Venbridge House, Cheriton Bishop, EX6 6HD

Design and Access Statement, Statement of Significance and Schedule of Works

December 2022 revision A

Appendix I: Pre-app report 22/01867/PREAPP

Photos above of annex bathroom and kitchen

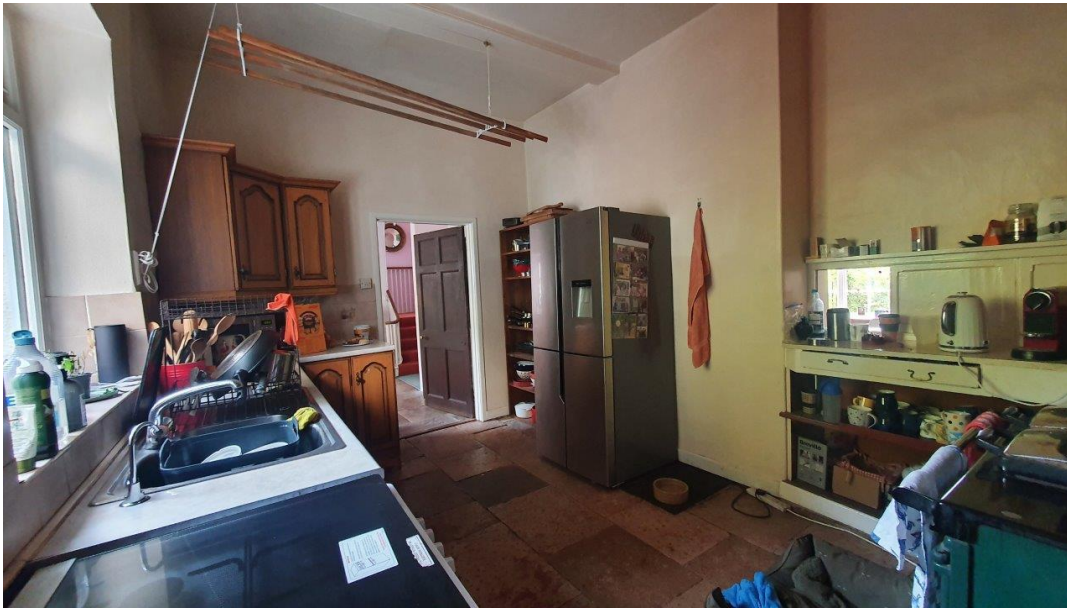
6. **Annex.** The annex is dark, poorly ventilated and insulated, with an awkward layout and unsympathetic internal and external finishes. It is damp and mouldy. Access to the main house is through a small doorway off the kitchen (which does not appear to be original) through the study to the hall, resulting in the study becoming a corridor. See picture below - Annex door viewed from study in main house (to left of chimney breast).

- *No objection to the replacement of external render with lime or the installation of a limecrete floor, which will all be beneficial to the building.*

- *No objection in principle to the introduction of a FF studwall to create a second bedroom.*
- *No objection to the alterations in floorplan within the “infill” link between the main house and outbuilding/annexe/garage, as this section of the building is almost totally modern.*

Works to improve the damp are noted above – see point 1: - replacement to cement render inside and out and replacement of concrete floor slab with a breathable limecrete floor. Existing windows to be retained. Re-orientating the ground floor entrance, kitchen, bathroom as shown in the submitted plans would bring in south light and a greater connection to the south facing garden. The kitchen would no longer be a corridor off the entrance door and by infilling the new

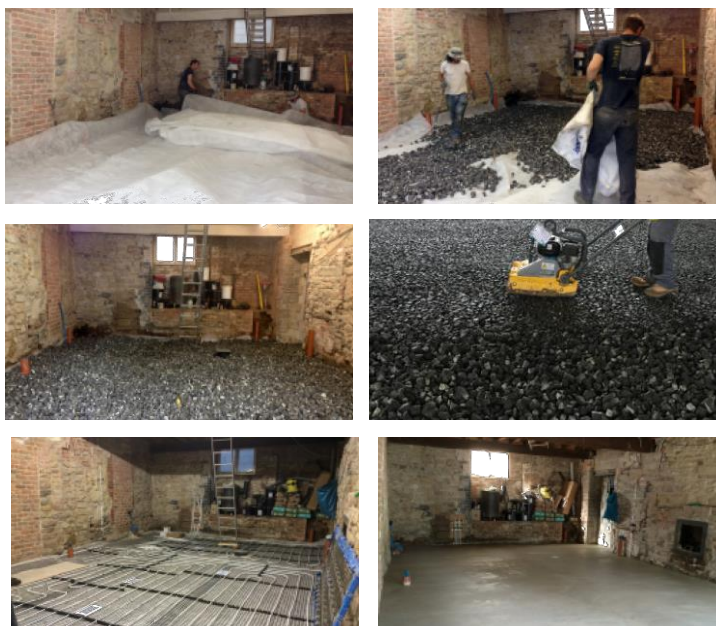
- *Details of Limecrete floor – LBC required - (literature and cross section of construction) and Method Statement for render mixes (components for each coat and texture finish plus decoration) again submitted upfront or to be conditioned.*

Existing concrete floor to be removed. Excavate to a total depth of insulation, limecrete plus finishes (around 200mm). Care should be taken when excavating close to the original house and outbuilding walls to avoid undermining shallow footings.
